Urban Design Review Panel Report

1822 Bank Street

**RE: Urban Design Review Panel Report
Official Plan Amendment, Zoning By-law Amendment, and Plan of Subdivision Applications
1822 Bank Street**

VIEW FROM ABOVE NORTHWEST SHOWING 45 DEGREE ANGULAR PLANE

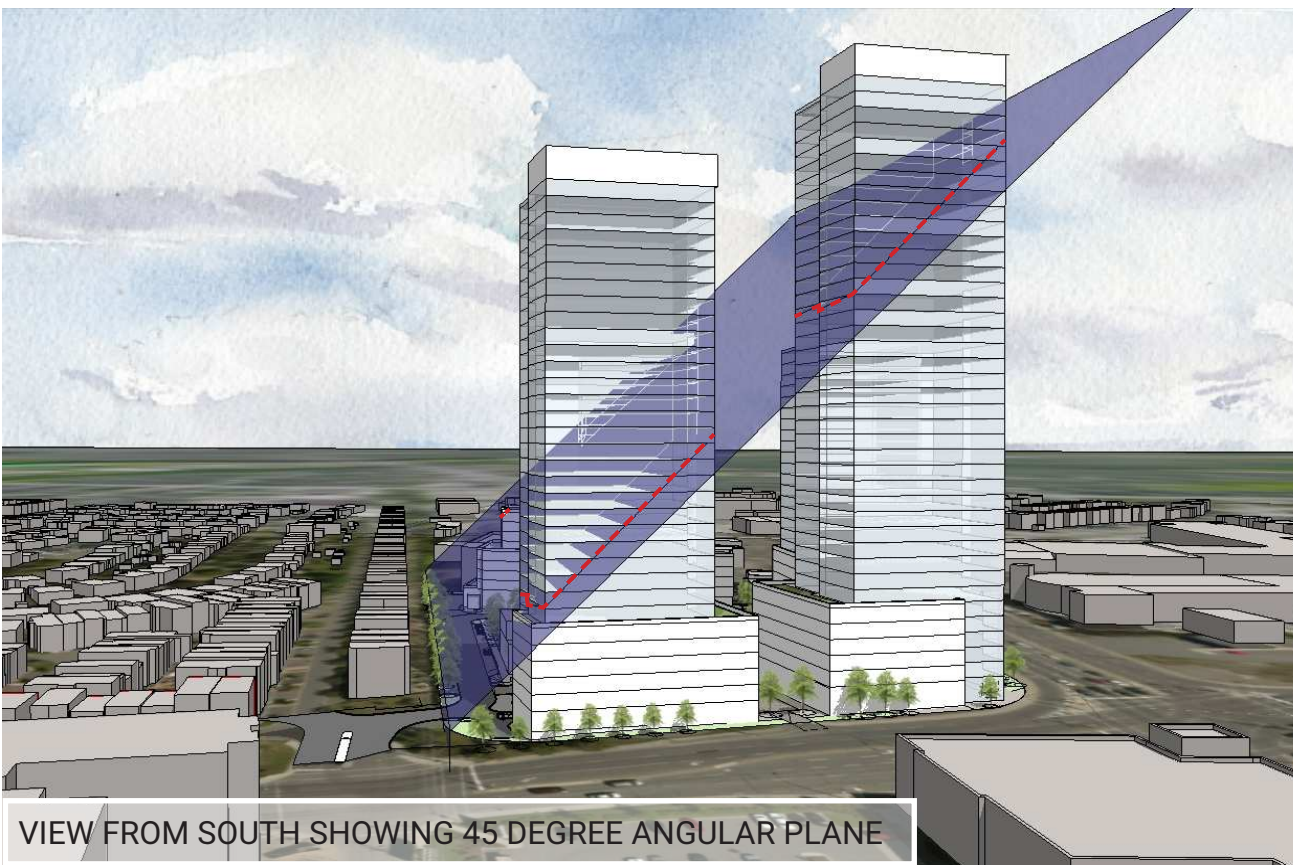
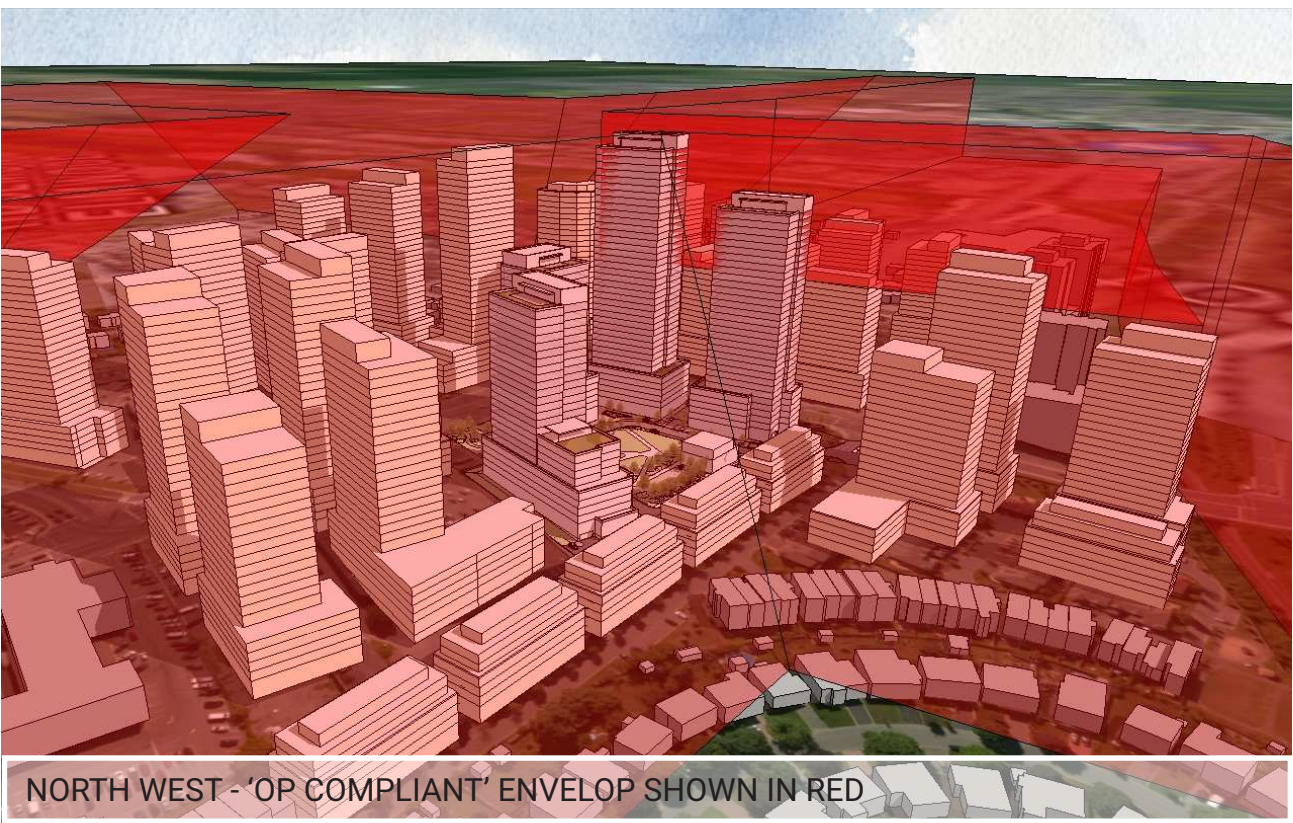
28. The Panel suggests Building 2 on the eastern edge of the site should go taller, bumping right up to meet the 45-degree angular plane shown on p.34 of presentation and perhaps even beyond it.

41. Ensure effective built form transition, guided by the application of angular planes.

Response: Building 3 (formerly Building 2) has been increased in height to 33 storeys. This change offsets the reduction in height on Building 1 (formerly building 5) at the southwest corner.

Applicant: Please refer to the angular plane diagrams included in the UDRP submission set. We feel that the proximity to the transit station and future development potential under the OP justifies some elements of the development breaking the 45 degree angular planes. The trade-off the proposed development offers is providing the majority of the western edge as greenspace. This minimizes the number of the existing townhomes impacted by overlook / shadowing.

CONCEPT SITE PLAN

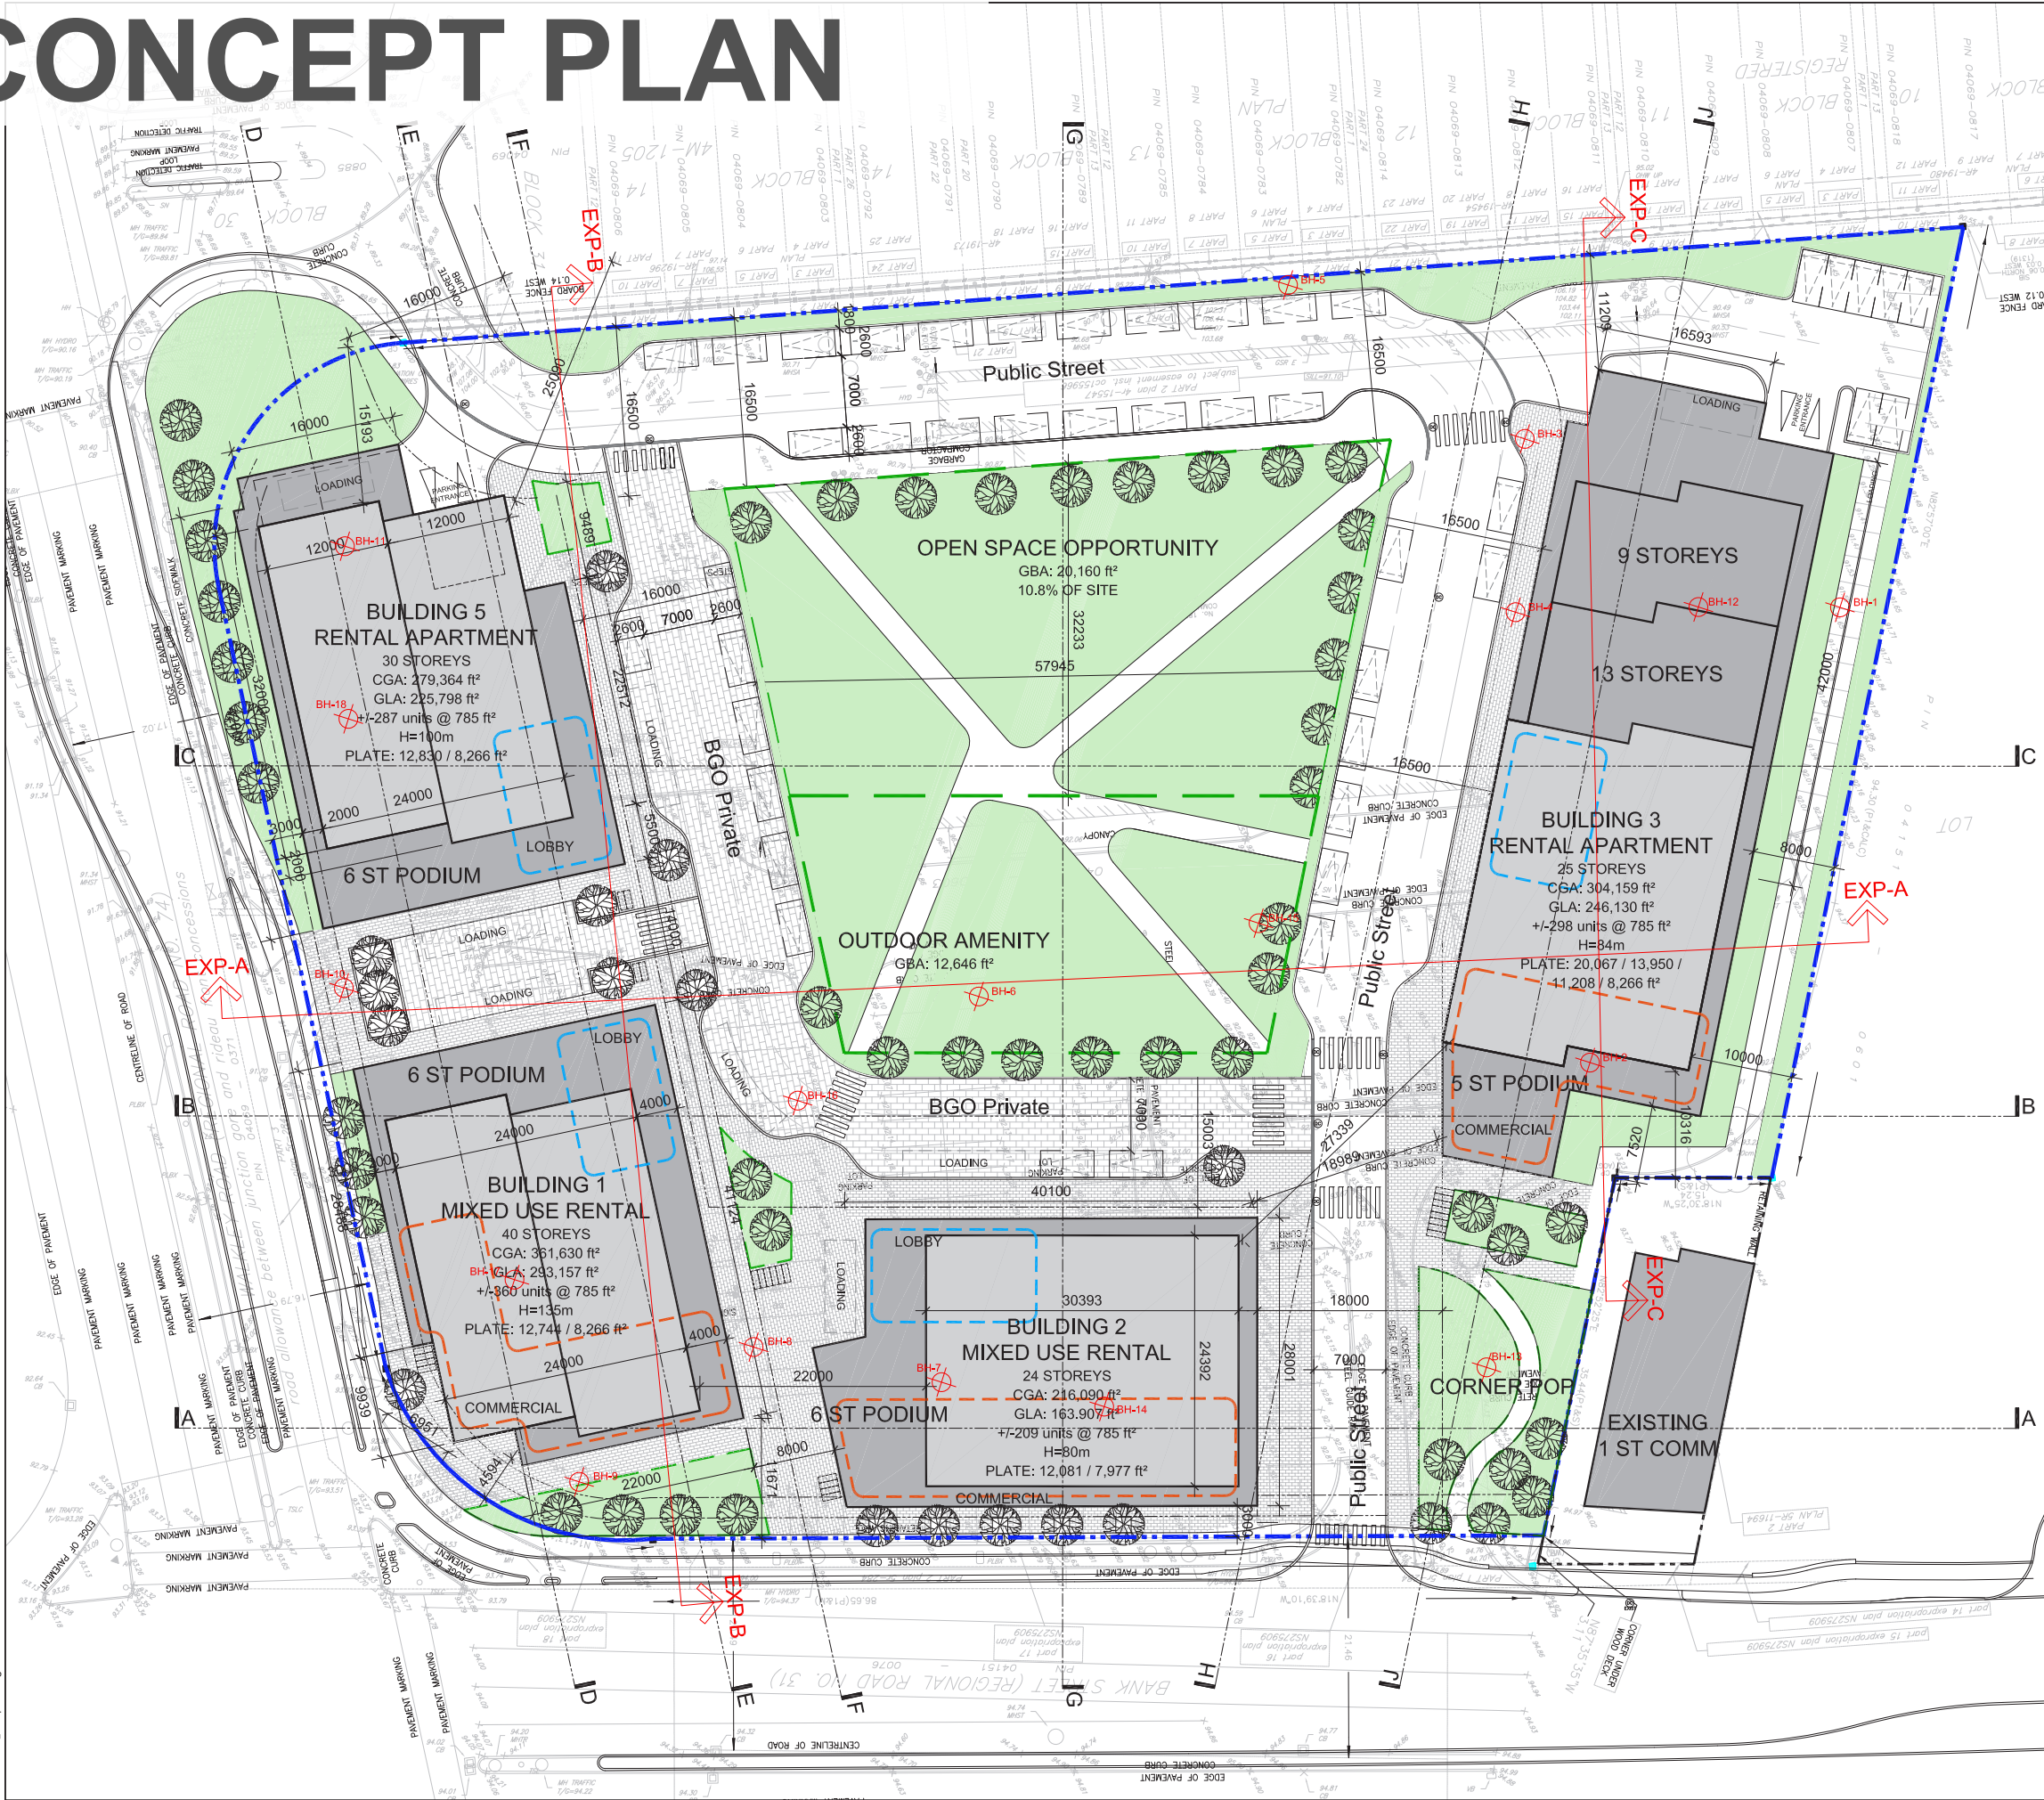
17. Some Panel members recommend forgoing the mid-rise option in/along the park space.

Response: The option for a midrise block has been removed.
